**APPENDIX E.7**  
**INSPECTION REPORTS**

**APPENDIX E.7.1**  
**AANDC INSPECTION REPORTS AND BAFFINLAND RESPONSE**

**RE: Water Licence Inspection Report – Mary River Project – Mary River Camp and Milne Inlet Camp May 4&5 2013.**

To: Memo to File  
From: Jim Millard  
cc:  
Date: March 25, 2014  
Re: Response to AANDC Inspections 2013

TM:tm  
Attachment(s)/Enclosure :  
Drawing: H349000-4138-10-015-0007

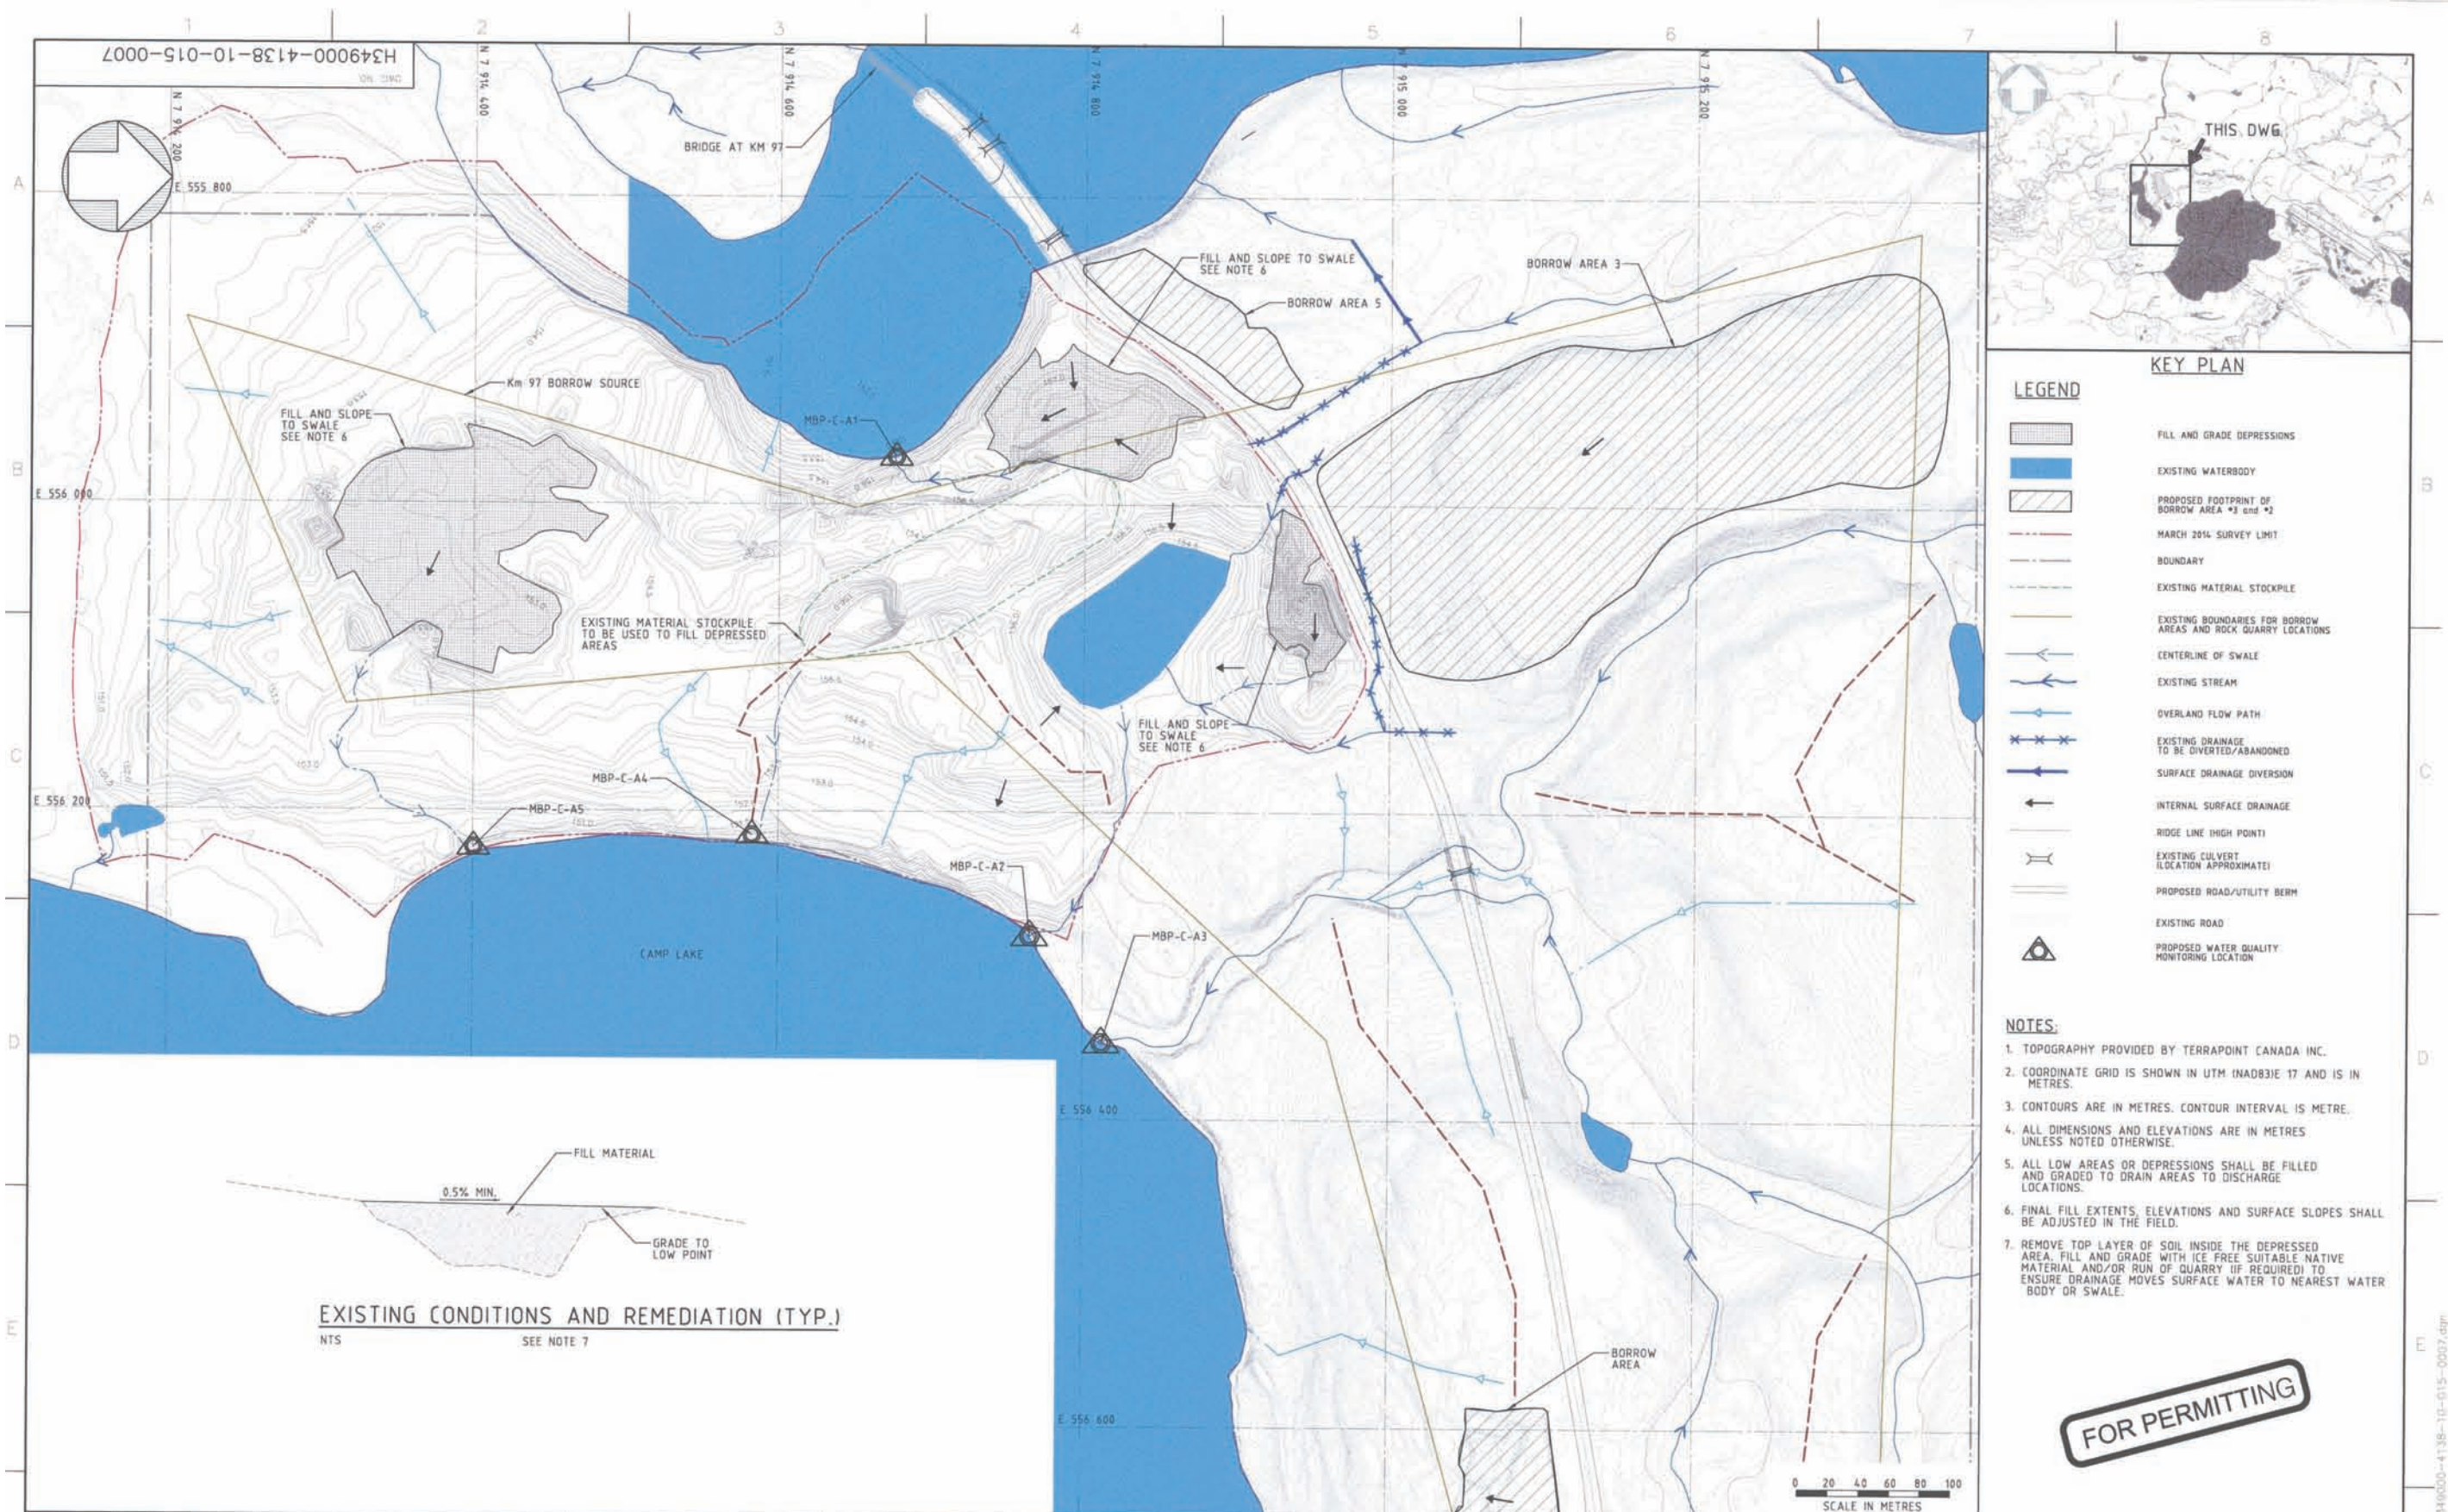
The borrow areas along the Tote Road have been an ongoing environmental concern to QIA. While QIA acknowledges that additional development along the Tote Road is planned, it remains uncertain as to which areas will be remediated and what the extent of the remediation programs will be. It is therefore recommended that a reclamation program be undertaken by BIMC to address the current and potential liabilities associated with the borrow areas along the Tote Road. It is recommended that a framework for the reclamation program be provided to QIA by March 31, 2014.

A drainage and rehabilitation plan for Km97 Borrow Source has been developed and is presented in drawing H349000-4138-10-015-0007. The conceptual approach for the drainage and rehabilitation plan is to divert water away from the site at the top and bottom of the existing slope so that accumulated surface water does not remain stagnant and allowed to pool or pond. In this effort, the following main steps will be taken:

- Where there is evidence of ponding, remove the degraded material from within the depression, replace with suitable ice free native fill and/or run of quarry (if required) material and re-grade.

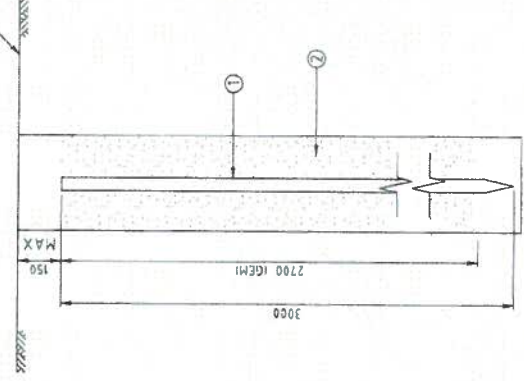
- 5 Please design this grounding detail and connect it to the E-houses internal ground bus.

- a. Pile casings (at least where pile caps are above grade)
  - b. Plate electrodes or grounding mats
  - c. Chemical electrodes.
6. 600 V secondary distribution systems should adopt a similar grounding practice to primary distribution. The only notable exception is that secondary distribution systems would employ high resistance neutral grounding.

7. Every facility's main ground bus should be connected to the primary/secondary distribution grounding system at the 600 V service entrance.
8. Notwithstanding the previous clause, facilities requiring lightning protection should have a dedicated ground electrode in the form of a mat, mesh or grid. Deep-well electrodes are not recommended due to the extreme depth of the permafrost. Lightning protection systems should be connected to the primary/secondary distribution grounding system as required by code. Due to the low isokeuronic levels on-site, it is anticipated that only the most exposed and/or critical facilities would have lightning protection.

9. Notwithstanding CSA M421 requirements for soil resistivity testing in a permafrost conditions, providing all energized parts and conductors are enclosed in grounded metal and the ground fault potential does not exceed 100 V, a station exemption in accordance with CEC 36-306 may be granted.
10. All buried ground connections should be exothermically welded (i.e. thermoweld). Above ground exposed connections can be either thermoweld or compression connections.
